CONCEPT PLAN CACHE RIDGE SUBDIVISION RIDGECREST AND 600 EAST CITY COUNCIL MEETING NOVEMBER 16, 2017

CACHE RIDGE SUBDIVISION CONCEPT PLAN HYRUM, UT. 84319

> > C-101

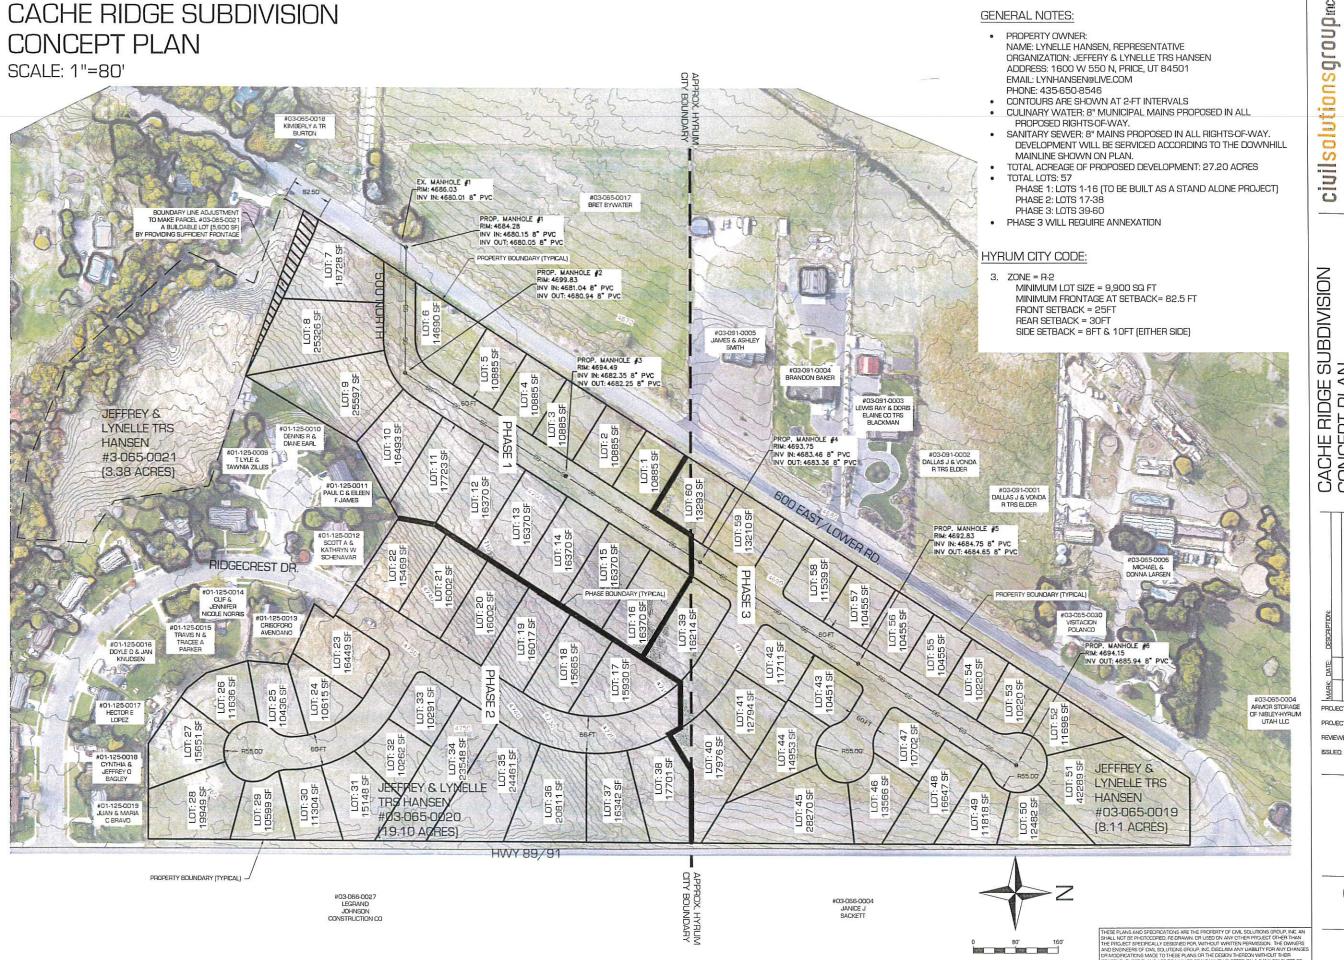
Stubbed in at Ridgecrest Subdivision and available on 600 East. May need to loop waterline from Ridgecrest to 600 East to meet fire flow requirements for phase one.

They plan to use the current access thru Ridgecrest. This road will remain a 68-foot ROW. Other roads will be 60-foot ROW's with the future phases creating two more connections onto 600 East. Staff has recommended that the houses don't have driveways onto 600 East because this street is intended as a secondary arterial roadway. They do not plan to access Highway 165 from any new roads. Along Highway 165 and 600 East they will have double street sided lots that will require a landscaping feature to address this problem. They could do the same as we required of Little Bear Creek and install a six-foot vinyl fence.

The one cul-de-sac is a little longer but meets the fire regulations for access. They will need to annex the lower portion of the property for later approvals so approval will need to include that stipulation. Where this is a property that has view lots, it might be a good idea to recommend that trees be limited to 30 feet in height and that all lighting be dark sky compliant including lighting on the houses. The Planning Commission recommended approval with the following conditions: trees limited at 30' tall, dark sky lighting only, six-foot vinyl fencing required for 600 East & Highway 101, 600 East asphalt be widened to a minimum of 18.5' from center of current road on development side, trees required on 600 East, lower road be redesigned with a right angle to 600 East, Ridgecrest not be used for a construction entrance road, & annexation completed for phase 3.
